# DSS Firmware Updates

- Contents of PCO 001.
- Designs affected.
- Problems \* / Solutions.
  - \* Also known as “*Design Features*”.
- Design Verification in R25 HDL.
- Future Modifications.

# Project Change Order - 001

# Update DSS CPLD's

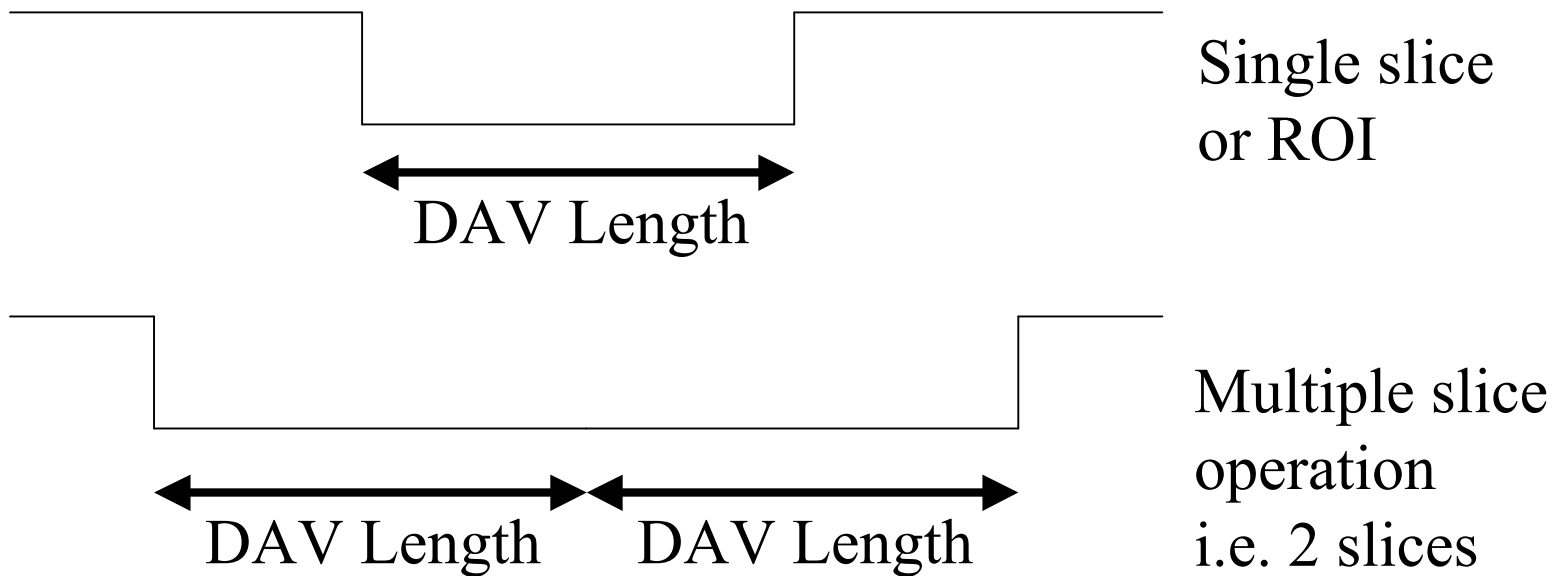
- The Xilinx CPLD on the DSS required modification in order to cope with the increased number of registers.
  - Created decoding for an extra 2 registers in each Data FPGA.
  - Also added the capability of an additional 2 registers in the SLINK FPGA's.

- So far only DSS's with serial numbers 01 and 03 have been updated CPLD's.
- Others **MUST** be updated before using with latest firmware.

# GIO daughter card - Source 1

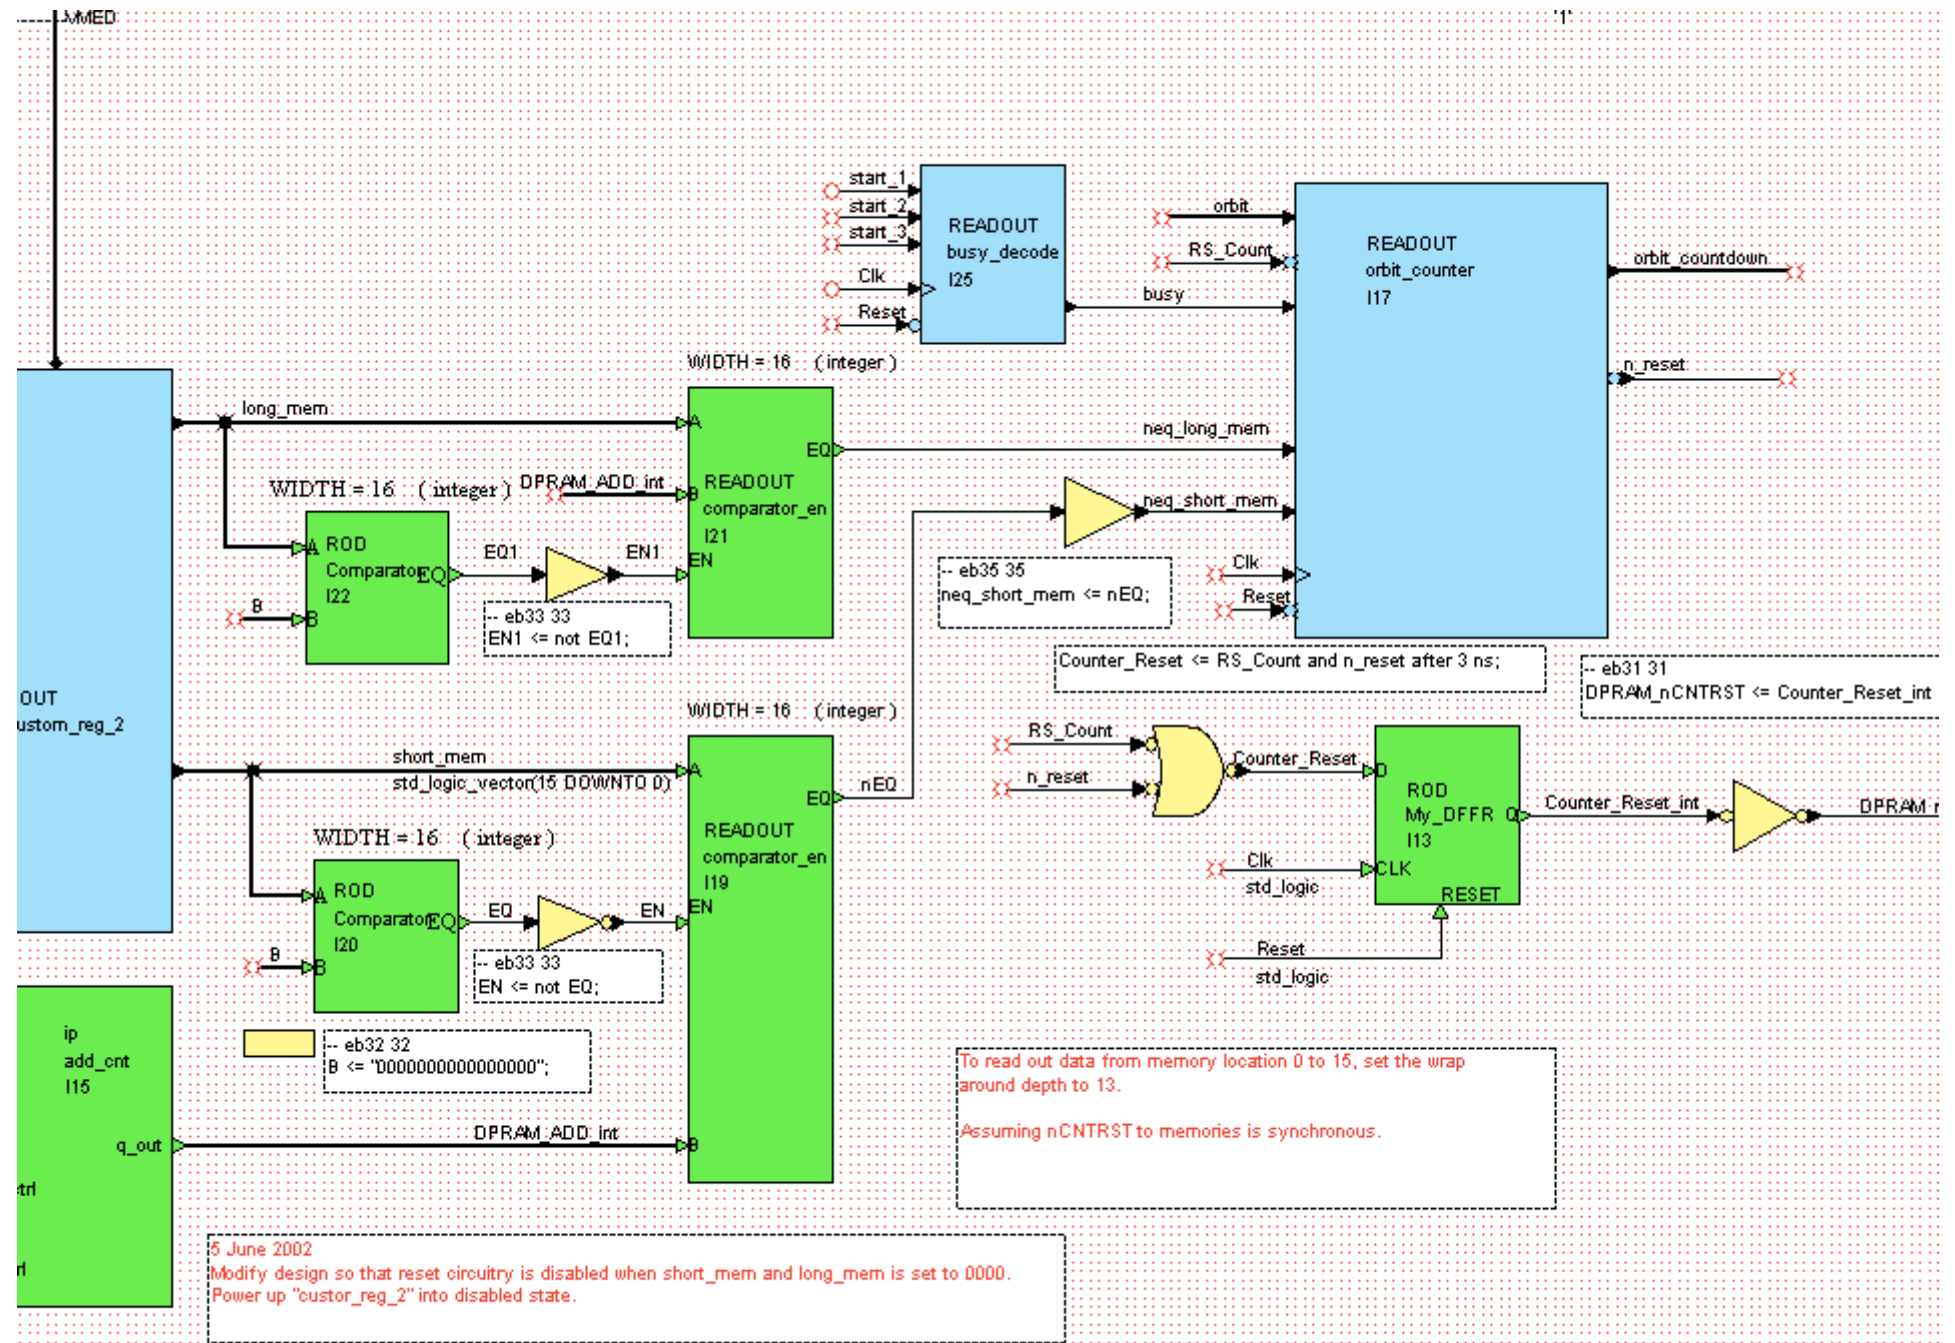
- Orbit register (32 bits) is at:-
  - Daughter Card 1:-
    - 108,10C, 110 and 114. (hex)
  - Daughter Card 2:-
    - 118,11C, 120 and 124. (hex)
- Note
  - This occupies the same address space as DAV register in "ROD test" design.

## Design Features Continued...

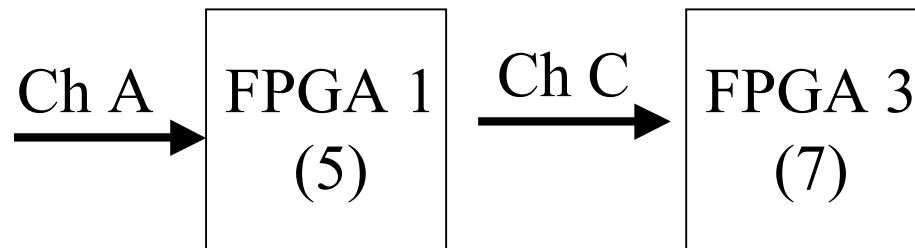
- The design relies upon the counter in the FPGA keeping track with the address counter in the memory chips.
- Due to latency in the design short\_mem and long\_mem should be set to a value of 2 less than the last data memory location required.

- Setting both `long_mem` and `short_mem` to `0x0000` will disable the RESET mechanism and allow rollover at 32k as normal.
- After loading the `orbit_countdown` register you should apply an “Address Counter Reset” to ensure that the value is transferred to the `orbit_countdown` counter.

# Automatic Comparison

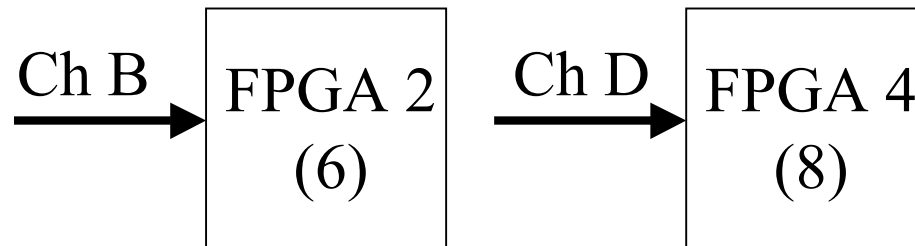
- Set bit high to disable the comparison of that data bit.
  - This allows the GIO data width of 32 bits to run within a design that originally allowed a data with of 80 bits (Previous daughter cards such as Glink or LVDS has data widths of 4x20).
    - FPGA 1 (5) - 20 bits
    - FPGA 2 (6) - 12 bits
      - () indicate Daughter card in slot 2.

Glink Cards  
A, B, C and D  
are 20 bits.

GIO Card  
A - 20 bits  
B - 12 bits
